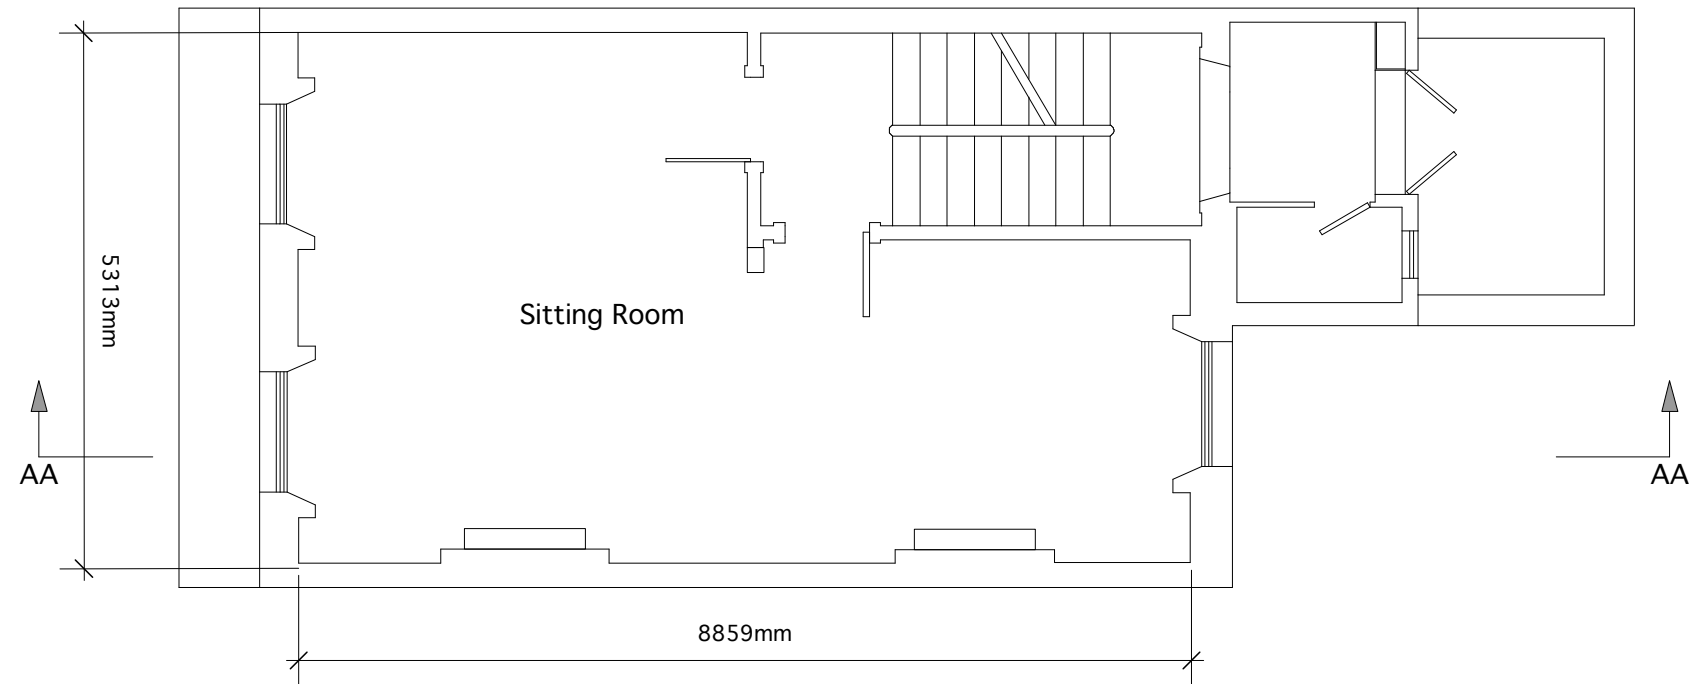
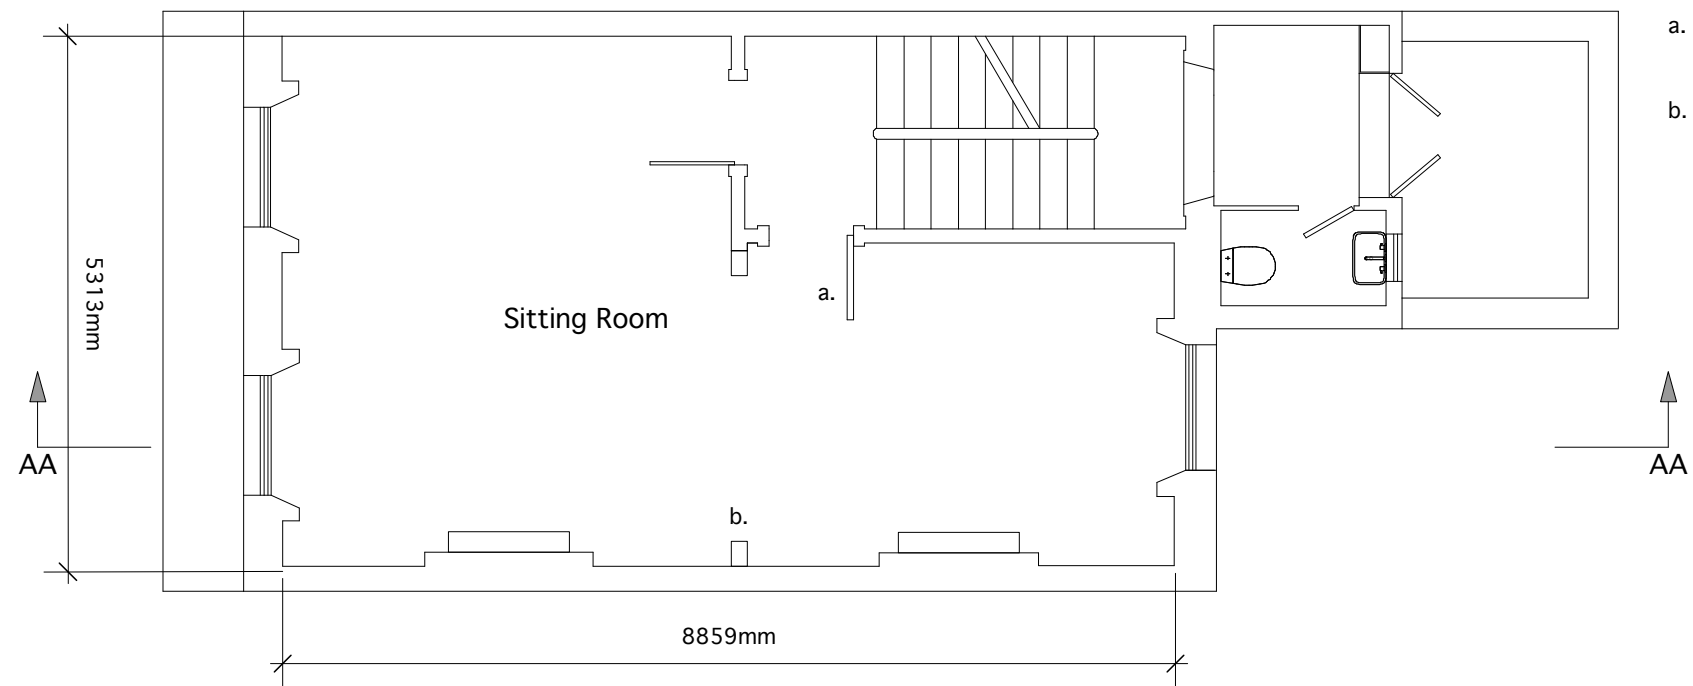
- a. Proposal to close opening from landing into sitting room
- b. Restoration or arch between front and rear areas  
Detailed in drawing REG/17-021
